An assessment by the Radiation and Nuclear Safety Authority on the periodic safety review of Loviisa NPP**Table of Contents**

Figure 2: STUK's indicator A.II.1 Number of operational events

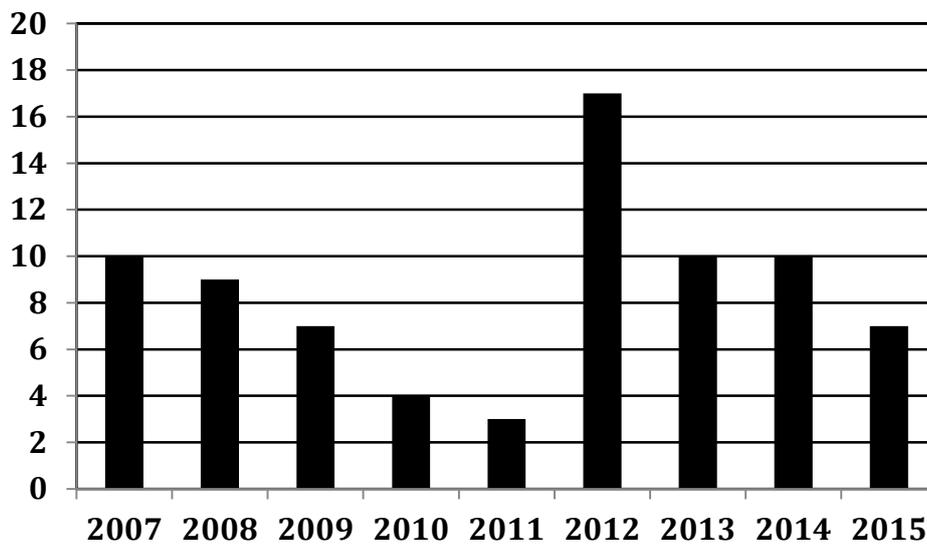
STUK has monitored the numbers of operational events to be reported according to YVL A.10 and any changes thereto on an annual basis. Based on STUK's indicator, the Loviisa power plant reported an average of nine events a year over the course of the review pe-

riod. A significant increase in specially reported events took place in 2012, as a result of which Fortum established a working group to resolve the matter. The working group identified improvement possibilities in the processing of operational events, for example, and the Loviisa power plant prepared an action plan to develop its operations. The goal of the development work concerning operational events was to, among other things, improve the utilisation of lessons learned from events and prevent the recurrence of the events. A core solution was to implement the measures required by Guide YVL A.10 in practice. STUK has monitored the progress of the development work through document reviews and within the scope of the Periodic Inspection Programme, for example.

In summary, the operational events at the Loviisa power plant have not substantially decreased the safety of the plant or caused any radioactive releases into the environment that would deviate from normal operation levels.

Figure 3. STUK indicator A.I.2 “Deviations from the TTKE – in violation of the TS”,

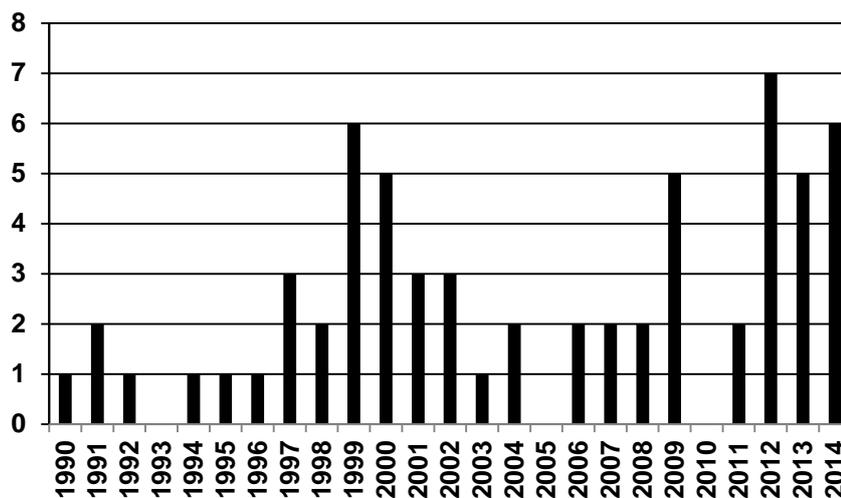
Despite the documented procedures and employee training, there have been some deviations unauthorised deviations from the Technical Specifications over the years. The power plant has in place the documented procedures required in Chapter 7.6 of Guide YVL A.6 and Chapter 3 of Guide YVL A.10 to identify these unauthorised TS deviations, determine their safety significance and reasons, along with specifying the corrective actions to prevent such events during future operation of the facility. STUK’s indicator shows that unauthorised TS deviations of this nature occur three times a year on average (based on a ten-year average between 2005 and 2014). The trend has become increasing since 2012 (Figure 3). The increase may have been caused by developments in event observation and reporting methods or a deterioration in operational practices, for example. At the beginning of 2013, Fortum established a working group to examine the increase in operational events, including the TS deviations. Towards the end of 2013, the Loviisa power plant prepared an action plan to develop the operations based on the research conducted by the Fortum working group. The measures were timed to be completed by the end of 2015. Fortum has supervised the implementation of the work, in addition to which STUK has monitored the progress of the development efforts in its inspections.

The conclusion is that the Technical Specifications of the Loviisa 1 and 2 nuclear power plant units have been implemented as intended in Section 22 of Regulation STUK Y/1/2016. In recent years, more deviations than before have been observed in compliance with the TS, which have resulted in analyses and the initiation of improvement measures. STUK has monitored the implementation of the measures through its inspection efforts. Based on STUK's assessment, TS is at an acceptable level in terms of safety.
